# FREDERICK COUNTY PLANNING COMMISSION

**ST. JOSEPH'S CARROLLTON MANOR  
ROMAN CATHOLIC CONGREGATION**

**SP 95-53 (AP #12122, APFO #12123  
& FRO #12124)**

**REQUEST:****Site Plan**

### Present Proposal:

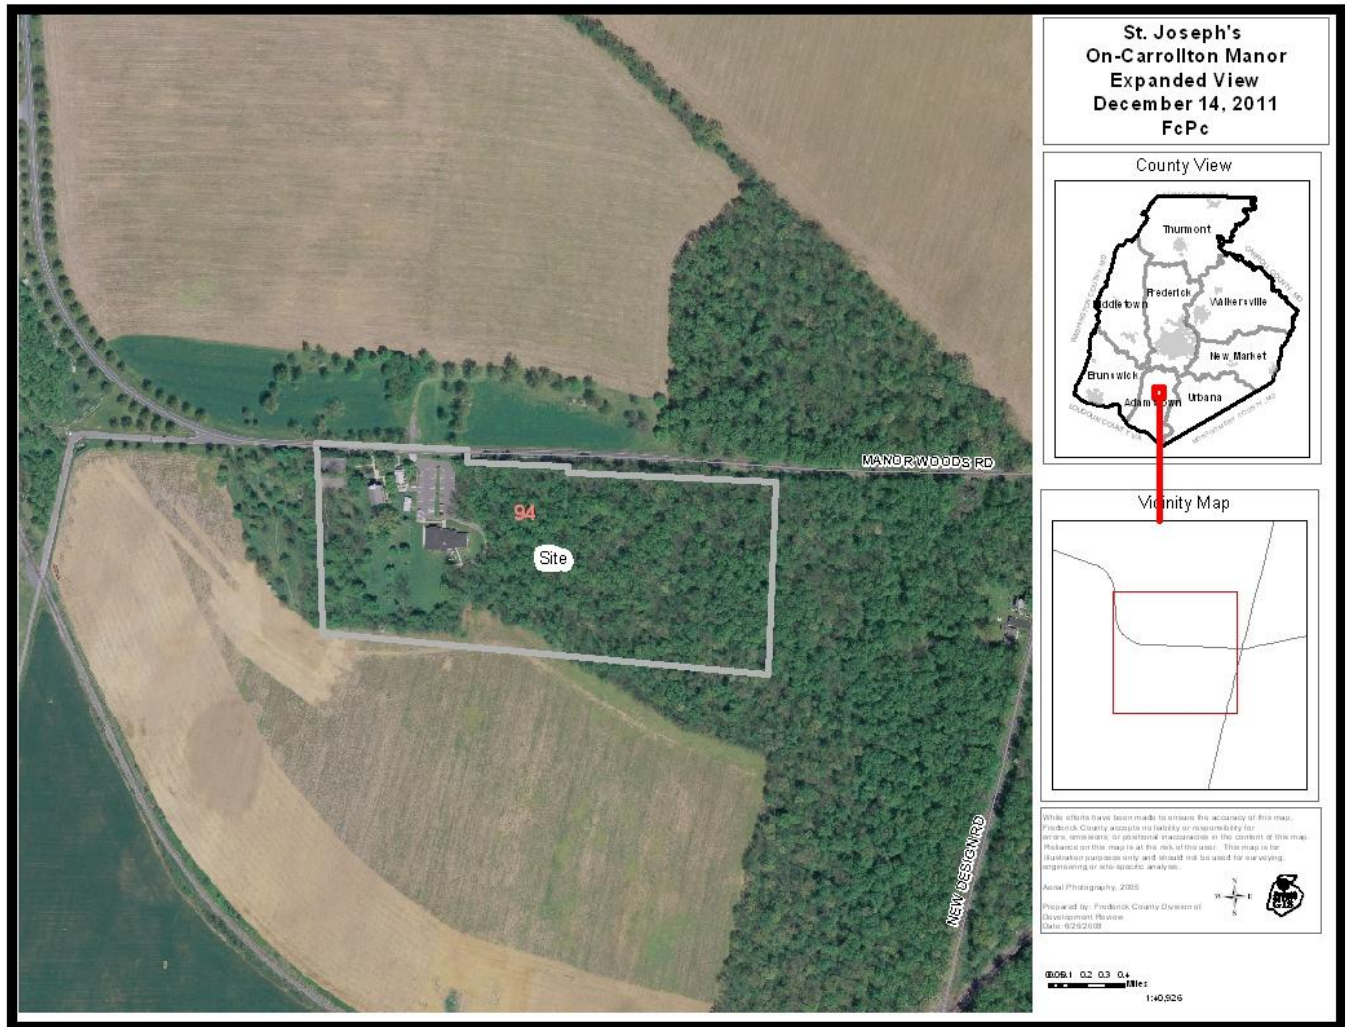
The Applicant is requesting site plan approval for the construction of a 14,796 square foot new church sanctuary and associated uses located on a 21.87-acre parcel. The development proposal is broken down into two phases; Phase 1 will consist of a 553-seat sanctuary addition, which includes 1<sup>st</sup> floor pews and seats in a mezzanine, as well as a 780 square foot church office. Phase 2 consists of a 400-seat sanctuary addition and 207 square feet of church office additions.
